SEWAGE DISPOSAL SYSTEM

MARYLAND STATE DEPARTMENT OF HEALTH

SUBDIVISION _____ ROAD 17014 Hardy Road LOT 33A

PLOT PLAN
 LOT 33A
 POPLAR HEIGHTS
 FOURTH ELECTION DISTRICT
 HOWARD COUNTY, MARYLAND

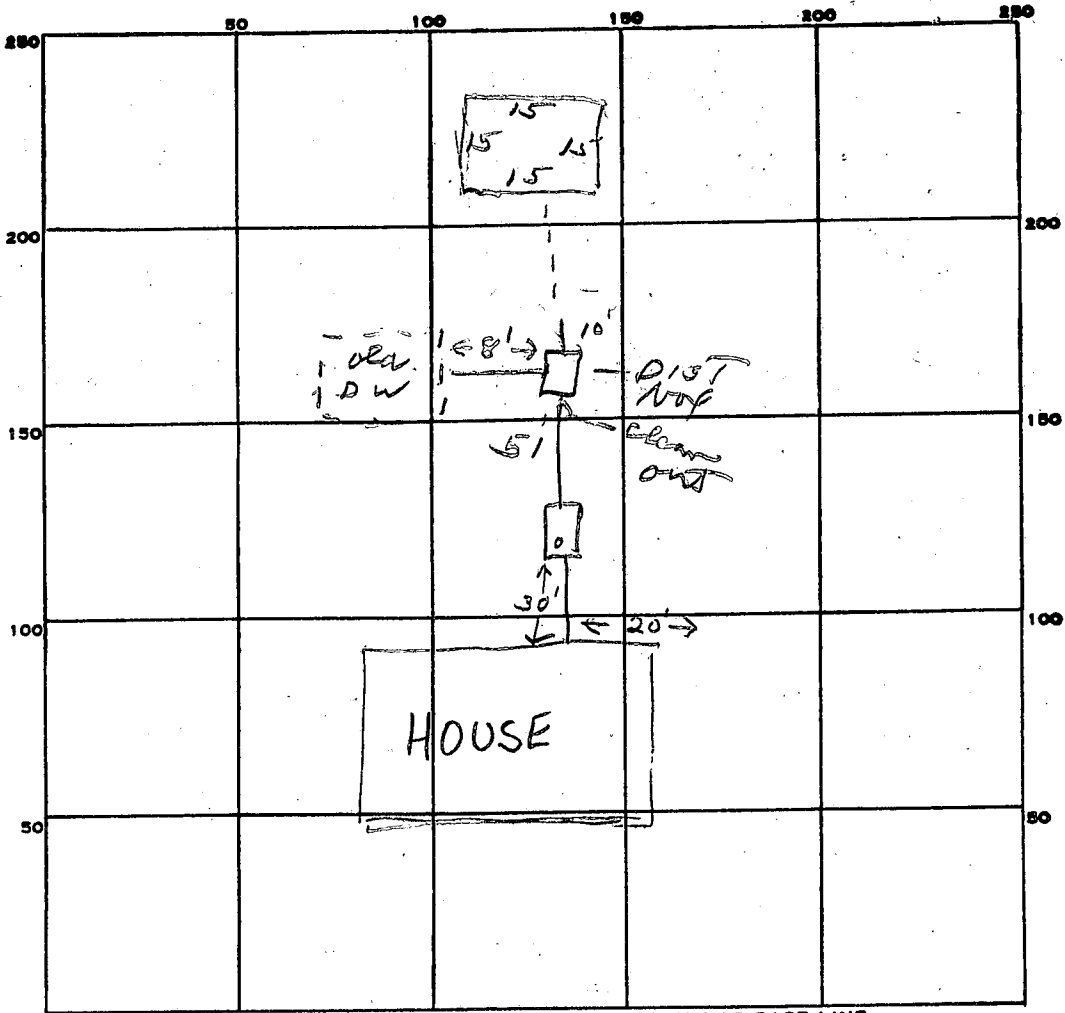
6/9/83 OK. To use existing drywell in lieu of 20' trench off new drywell. use a distribution box to connect 2 drywells to septic tank S.S.

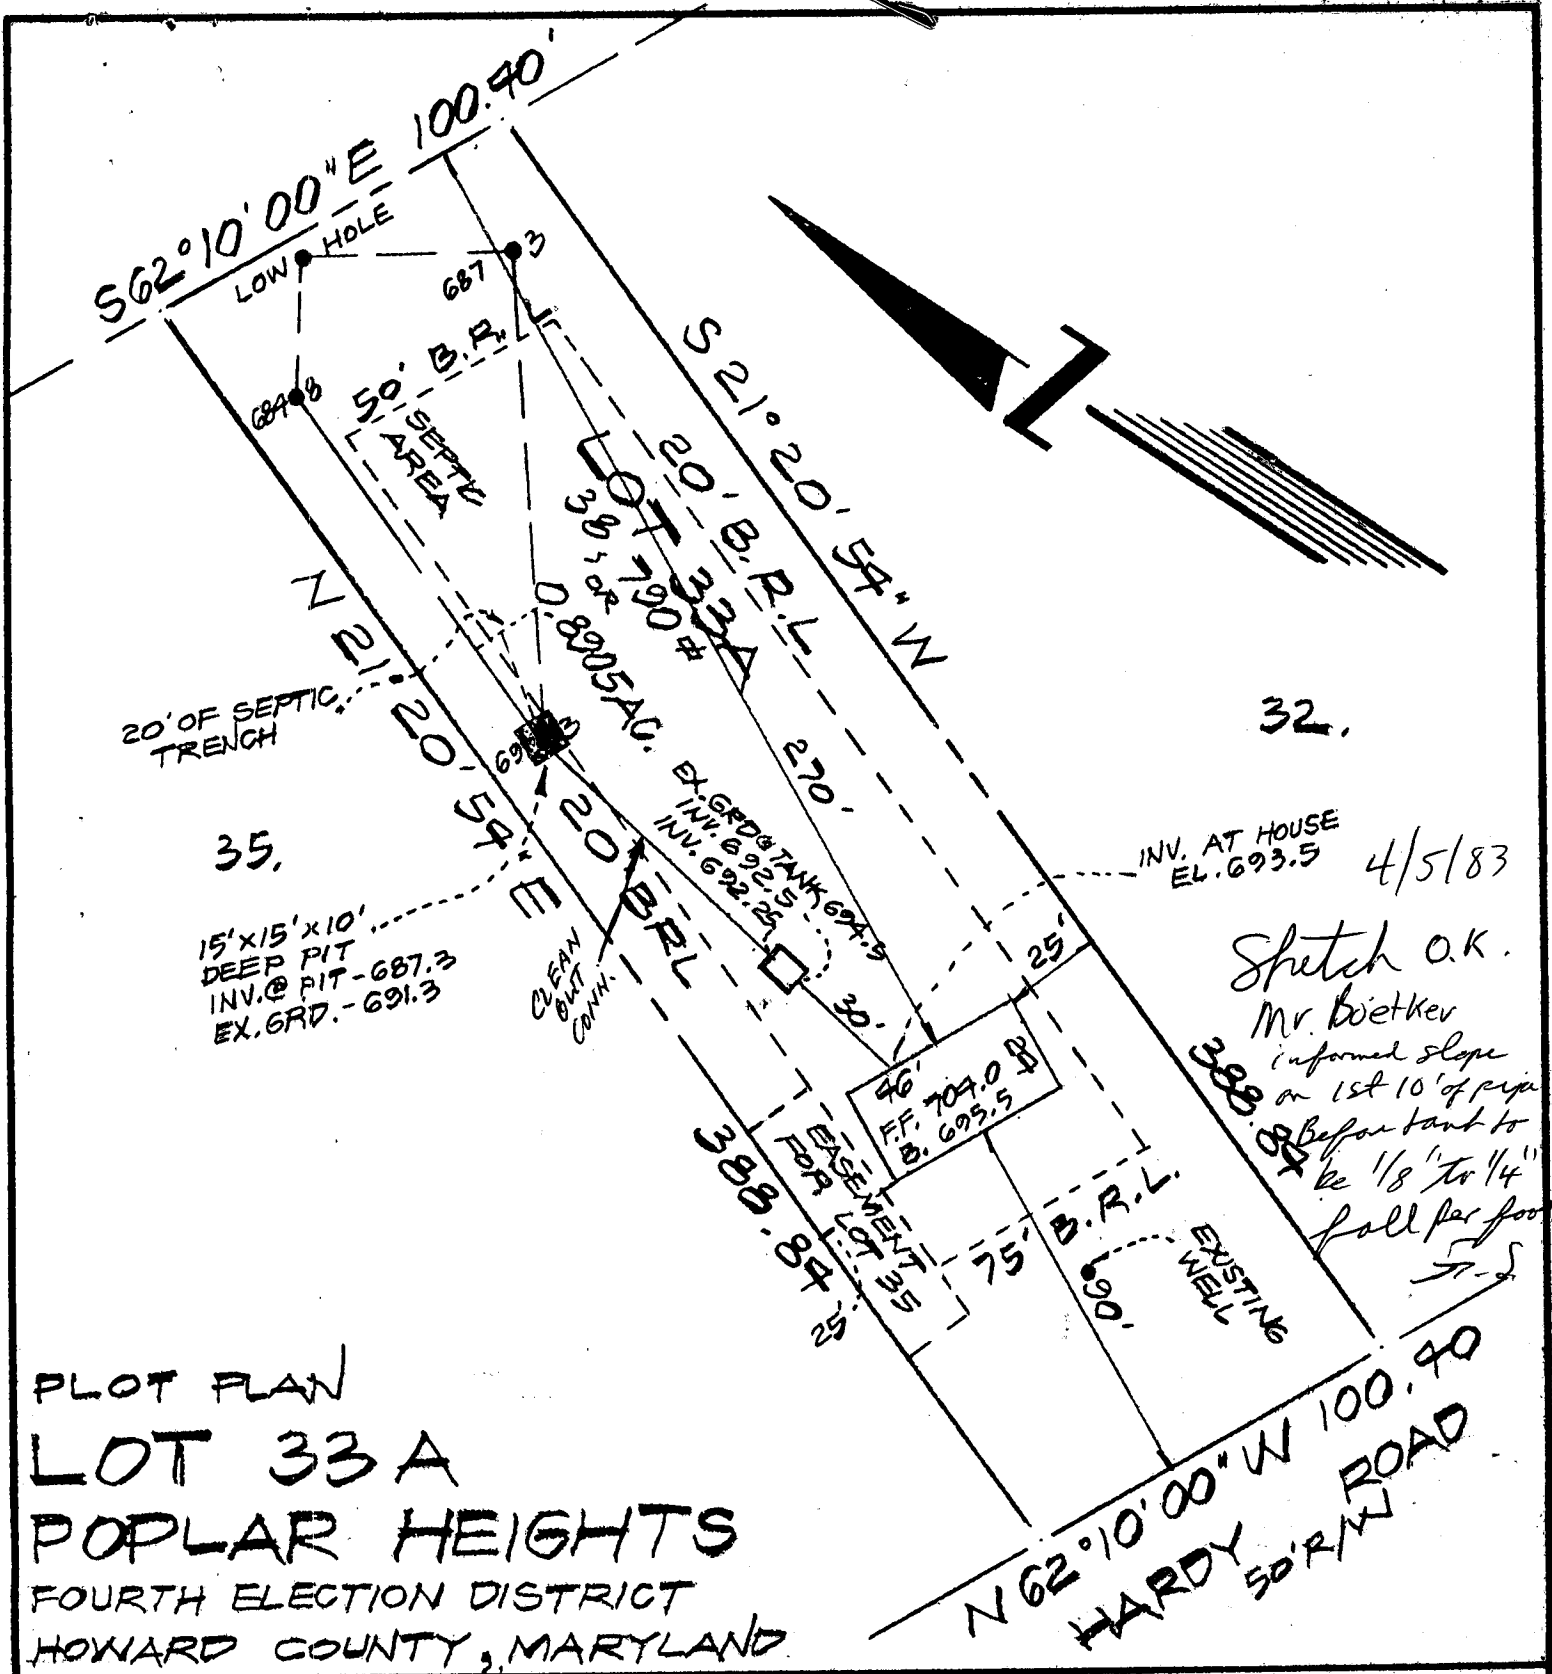
32.
 INV. AT HOUSE
 EL. 693.5 4/5/83
 Sketch O.K.
 Mr. Boetker
 informed slope
 on 1st 10' of pipe
 before tank to
 be 1/8" to 1/4"
 fall per foot
 S.S.

HARDY ROAD

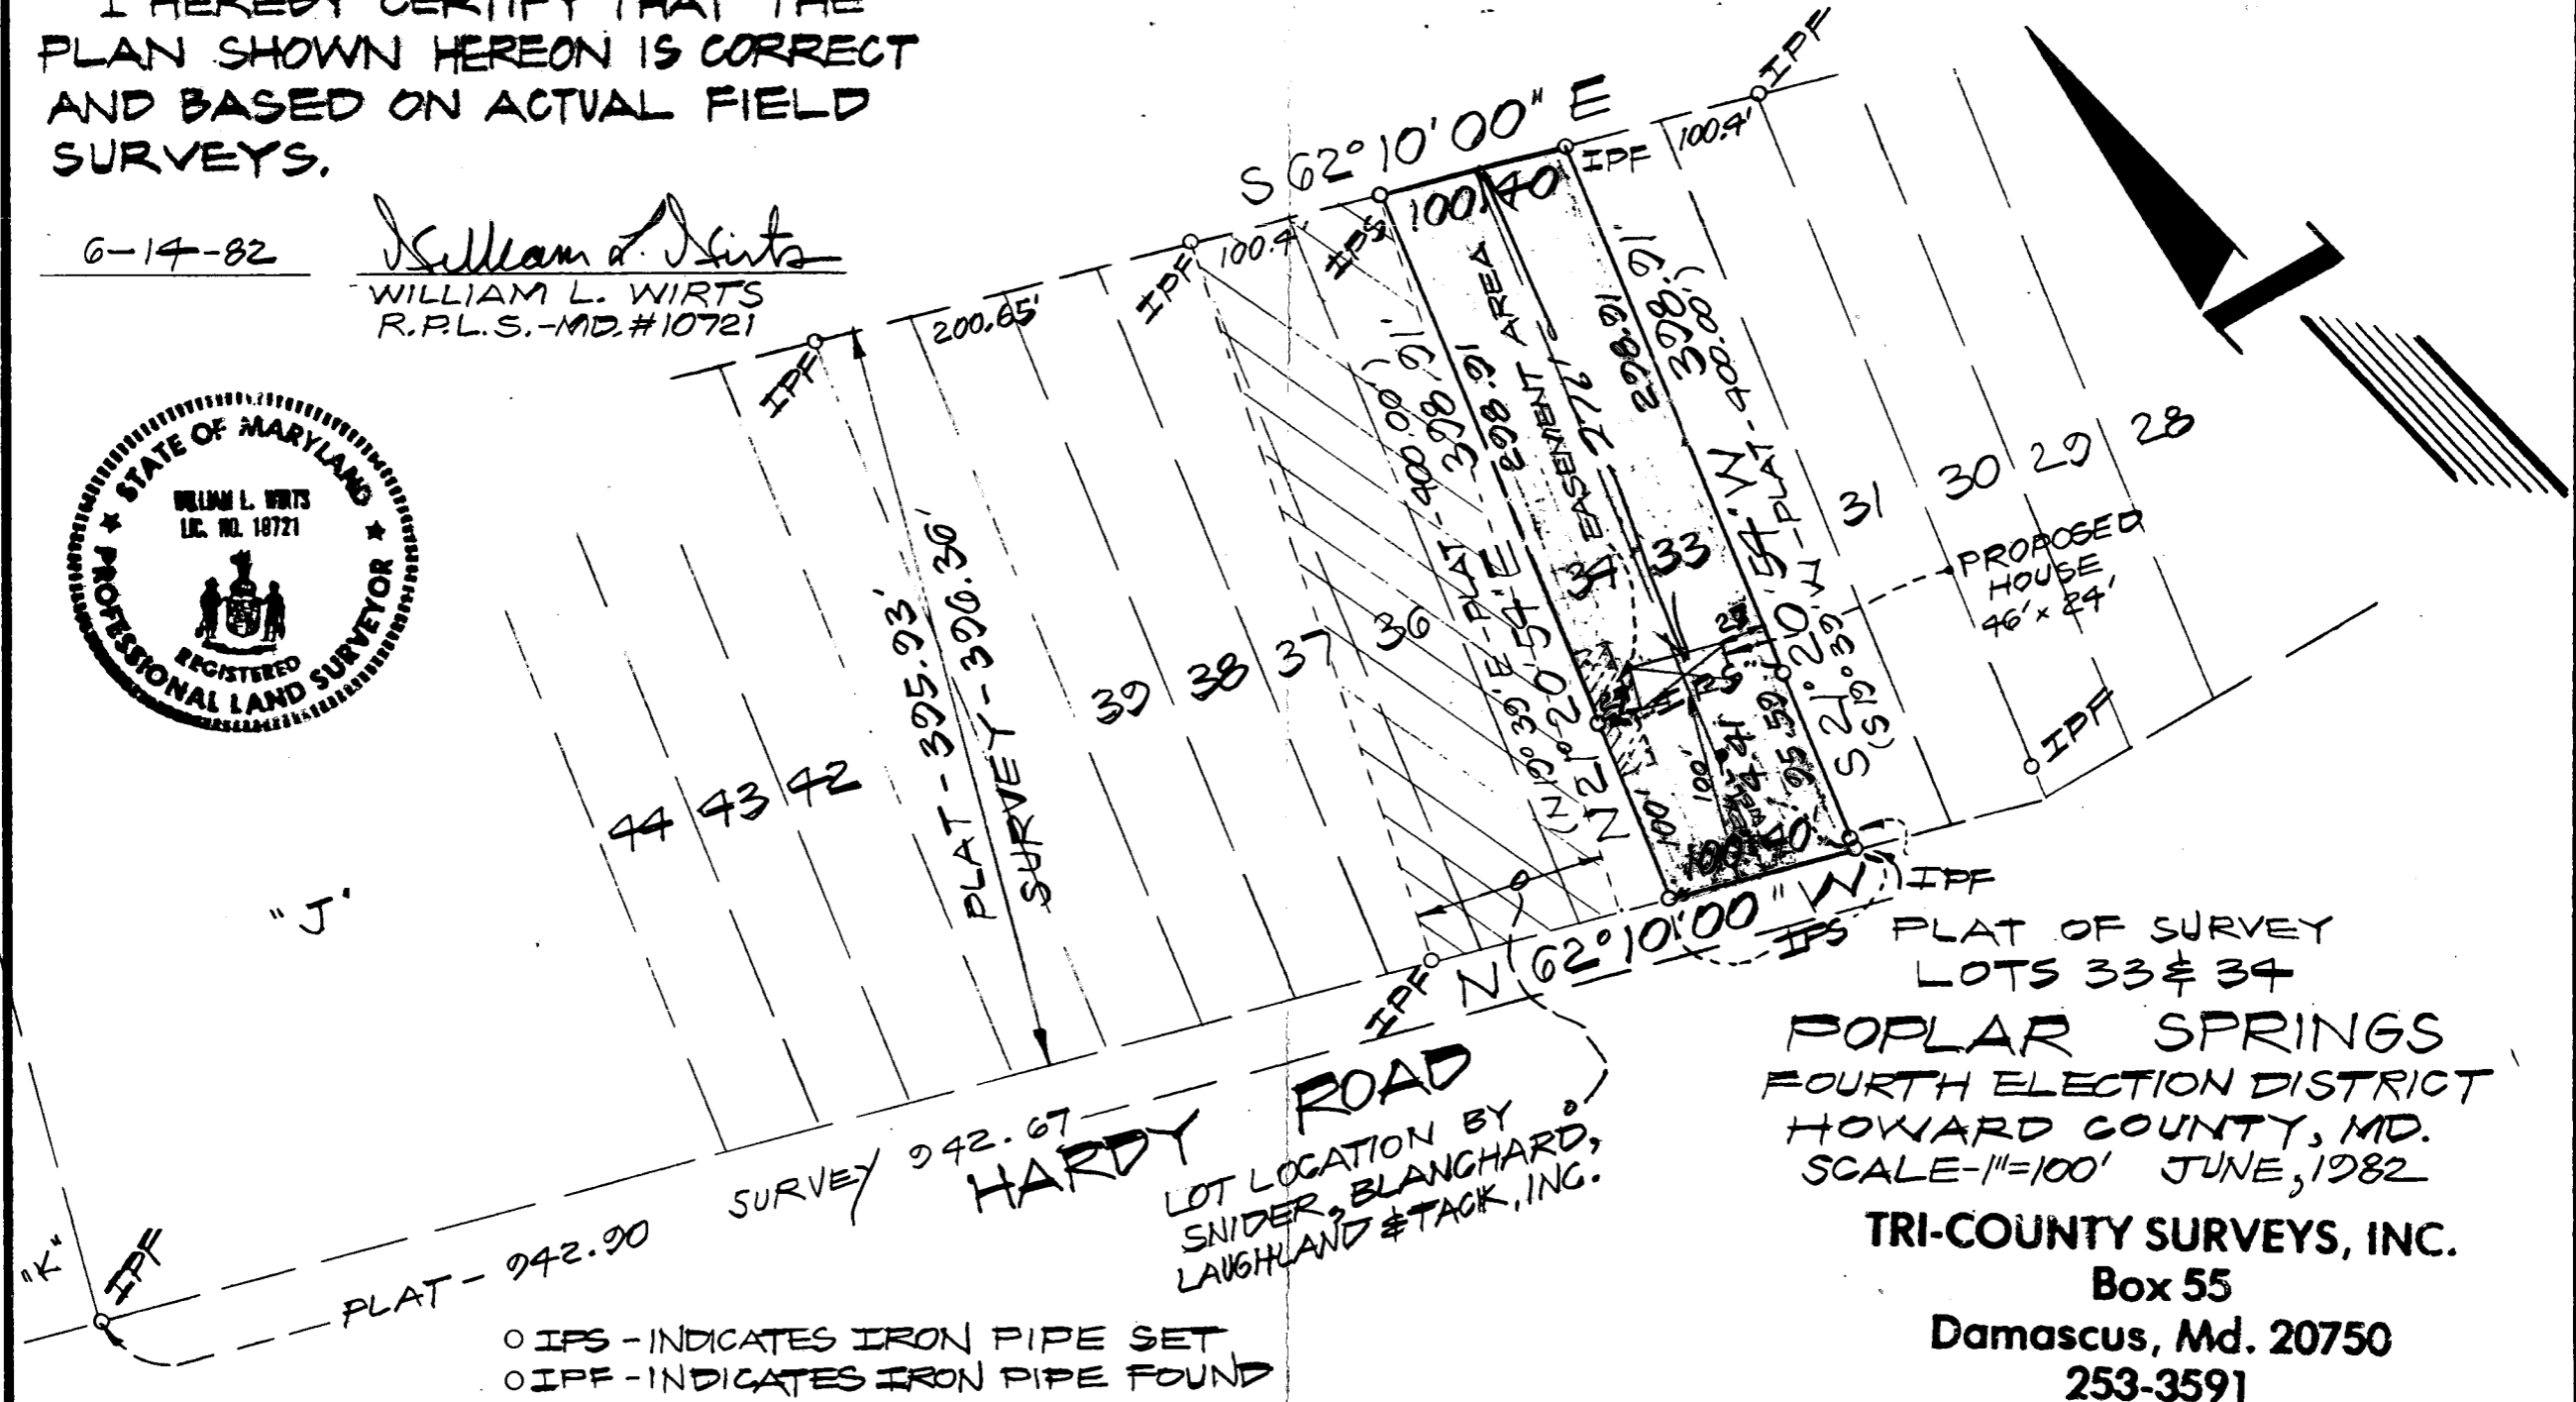
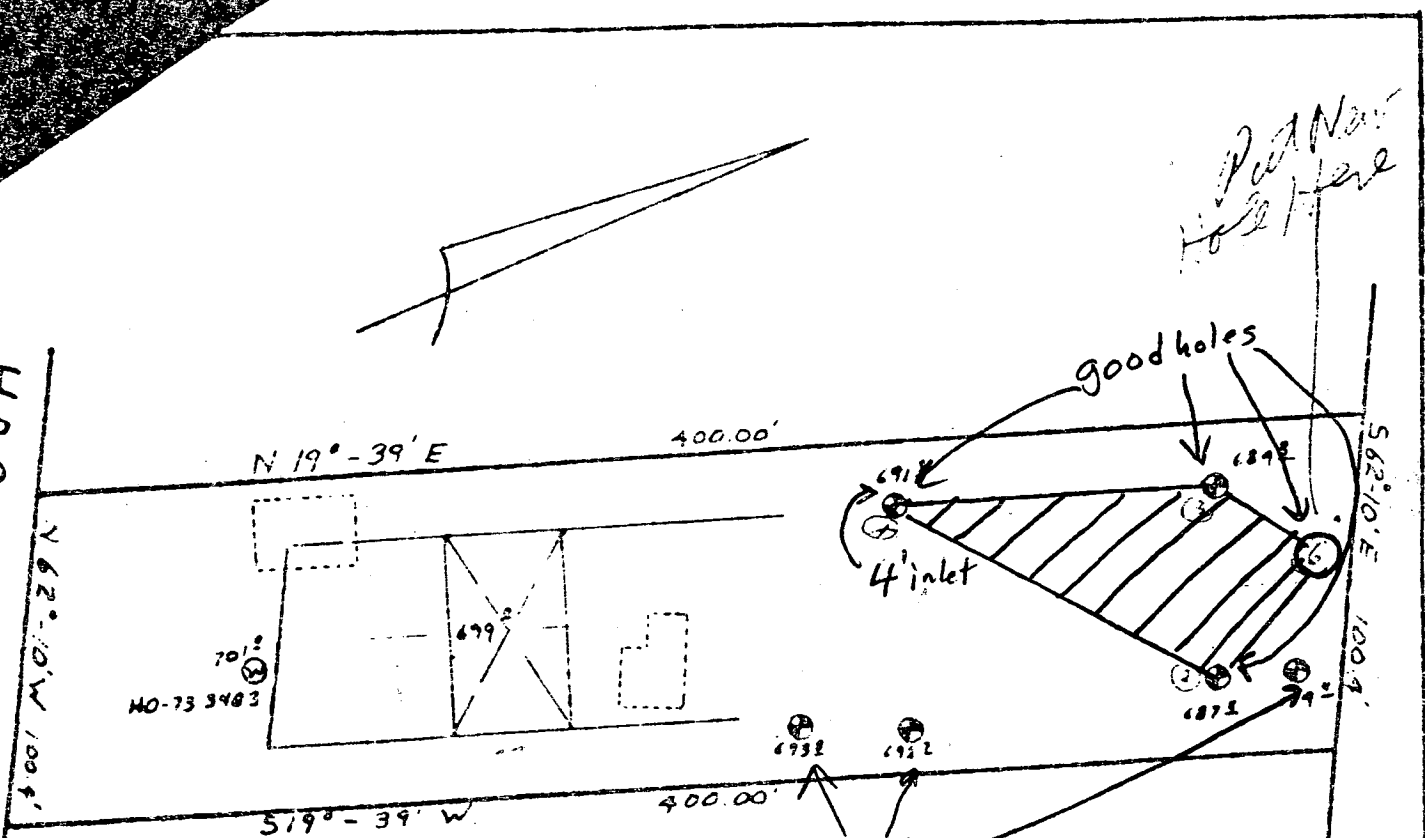
9/21/82
 Mr. Wirts: This drawing shows the approved private sewage easement for Lot 33A Poplar Heights. Please incorporate this area on the final record plat.
